(4) REQUIRED THUS
SERIES 810-I WINDOW
ARCH. REF. G/A6.1

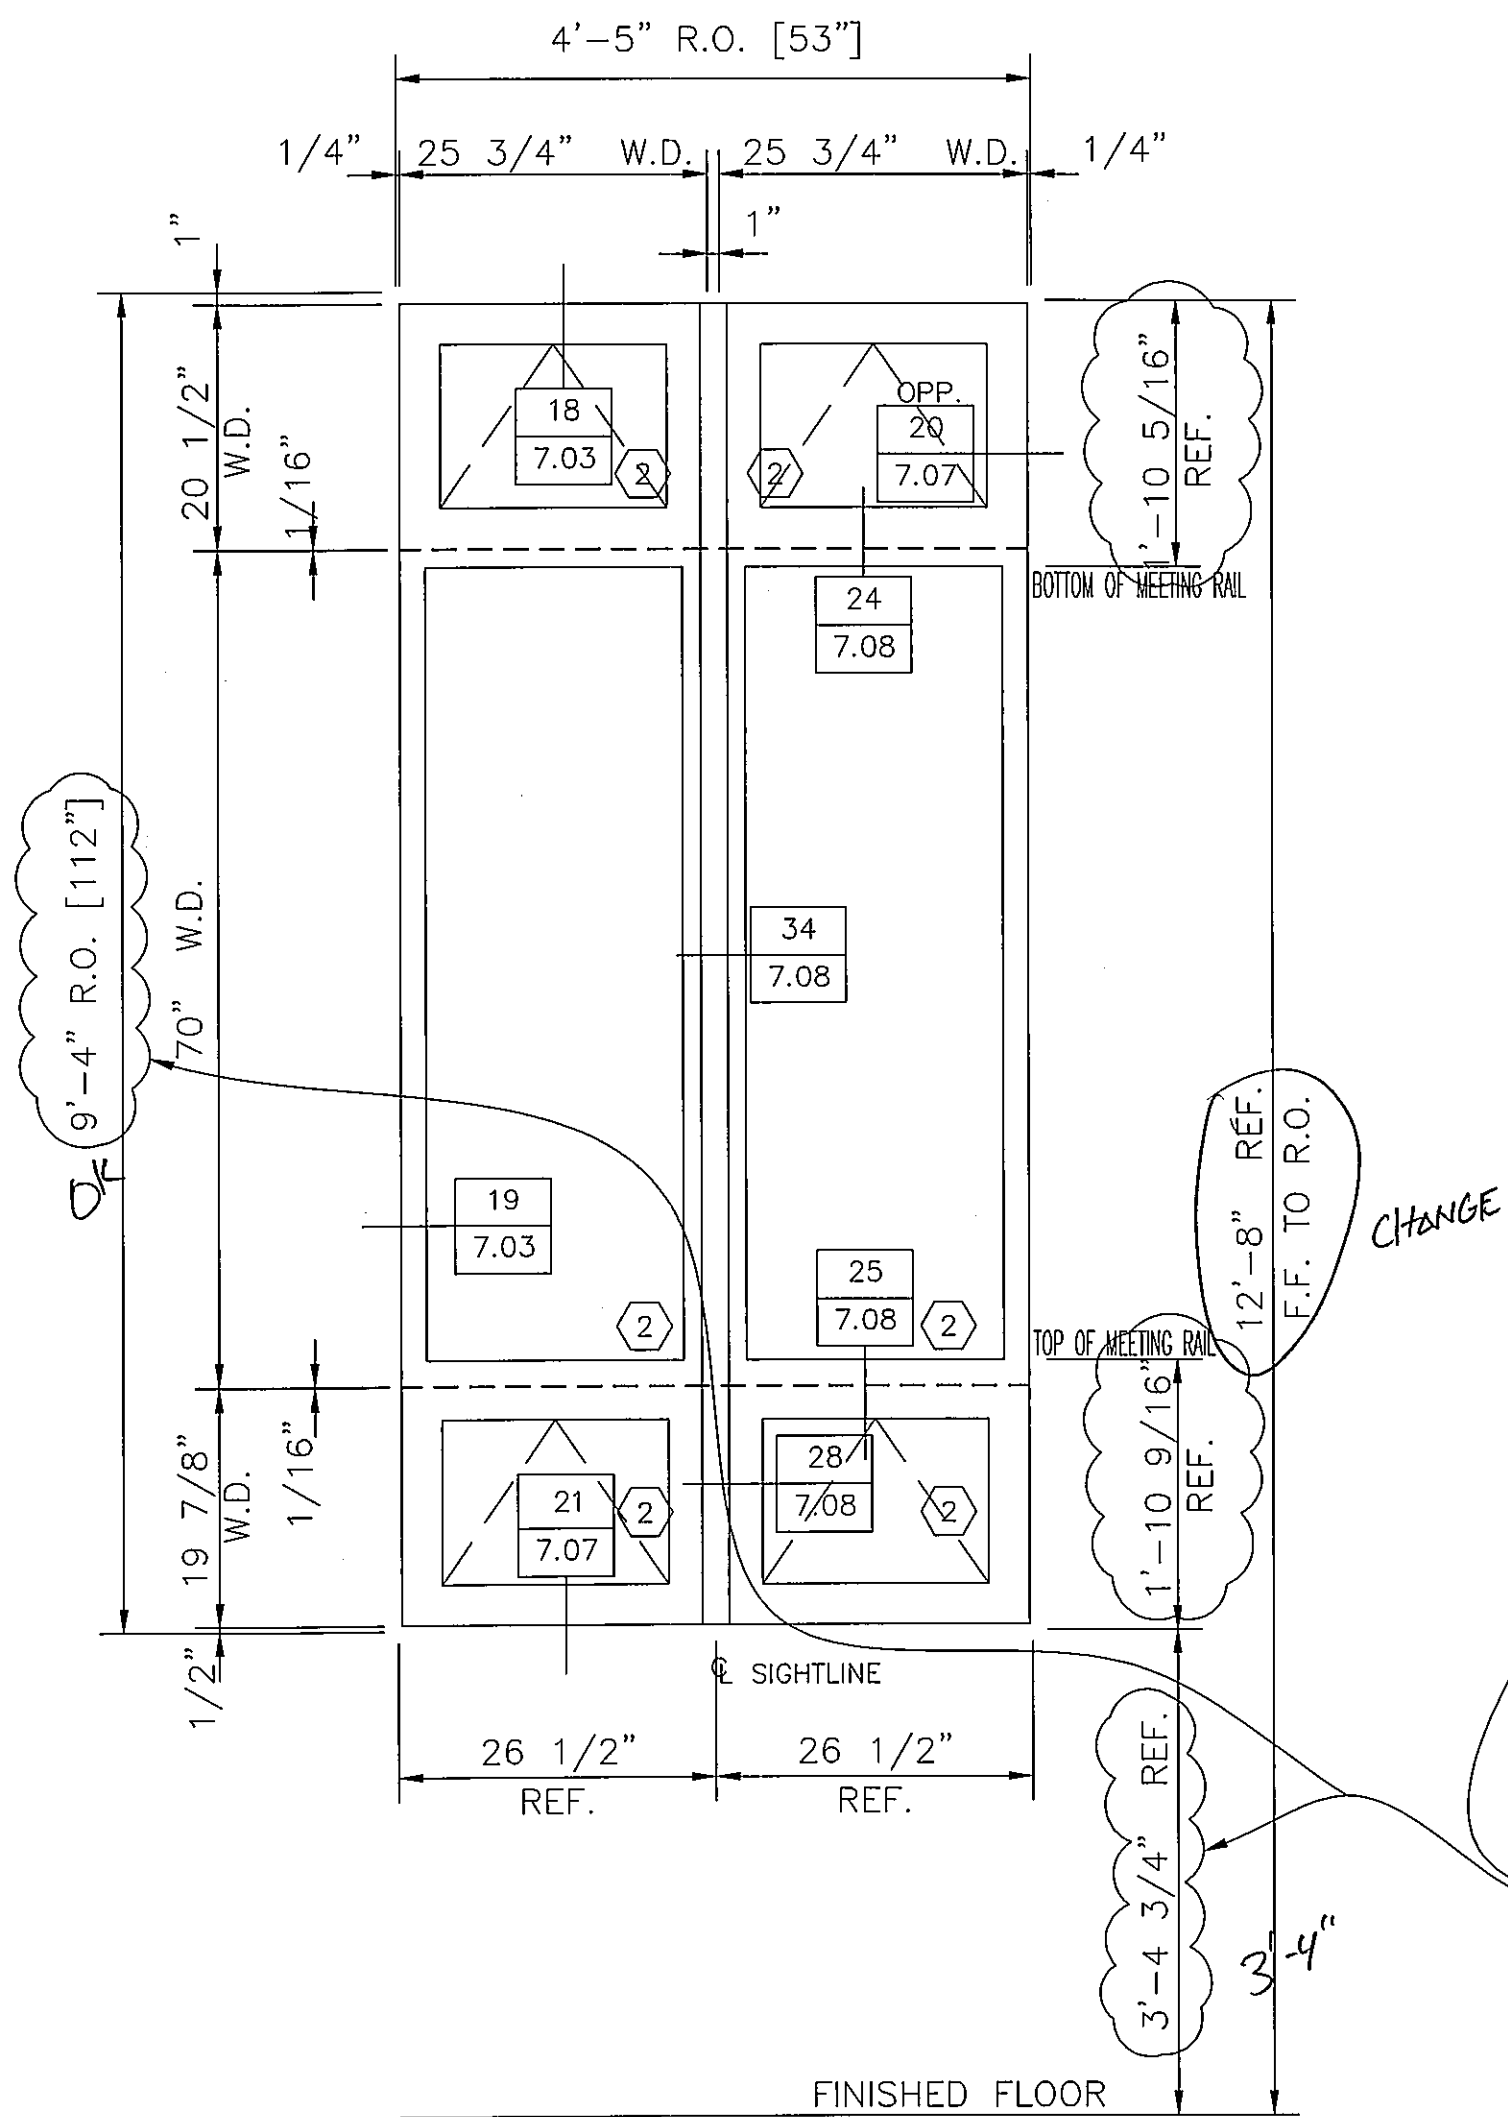
ARCH./G.C. NOTE:
PLEASE VERIFY IF THESE WINDOWS ON
THIS SHEET ARE TO BE P.O. OR P.I.

ARCH./G.C. NOTE:
REF. DIMENSIONS HAVE BEEN ALTERED
AT PROJECTED WINDOWS IN ORDER FOR
THE WINDOW TO USE SPECIFIED HARDWARE

(6) REQUIRED THUS
SERIES 810-I WINDOW
ARCH. REF. G/A6.1

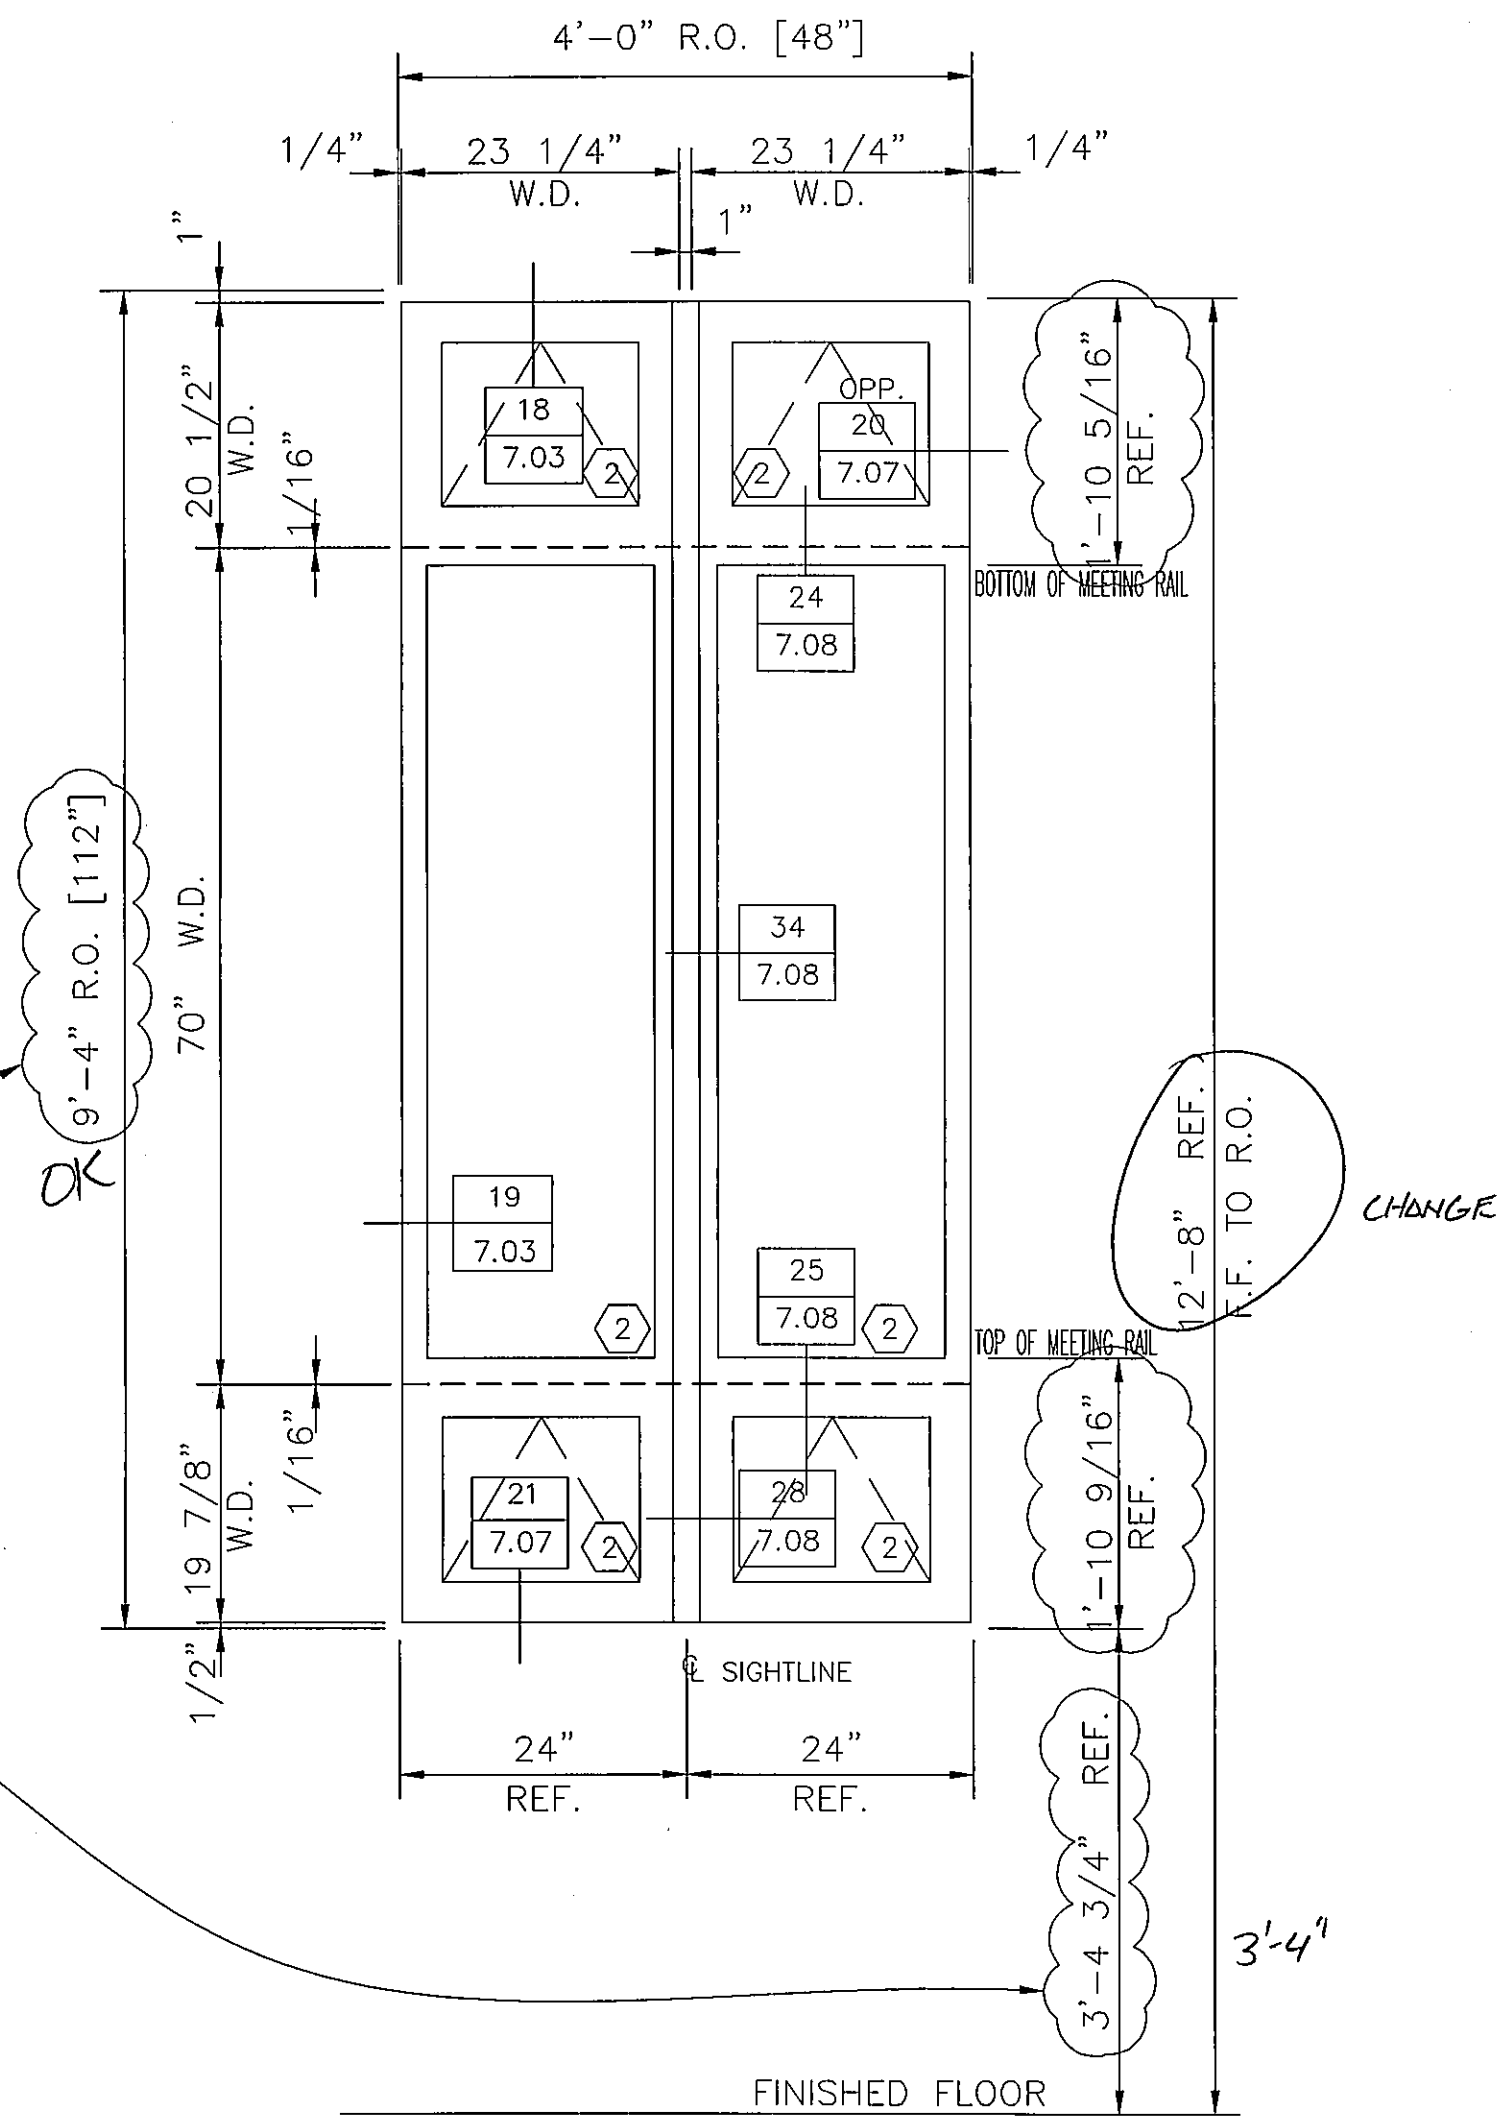
ARCH./G.C. NOTE:
USING THE NEW 12'-8" REF. DIM. (FROM
THE TOP OF R.O. TO FINISHED FLOOR),
EITHER THE 3'-4" REF. DIM. (FROM BOTTOM
OF R.O. TO FINISHED FLOOR) OR THE R.O.
MUST CHANGE. PLEASE VERIFY WHICH DIM.
IS TO BE ALTERED.
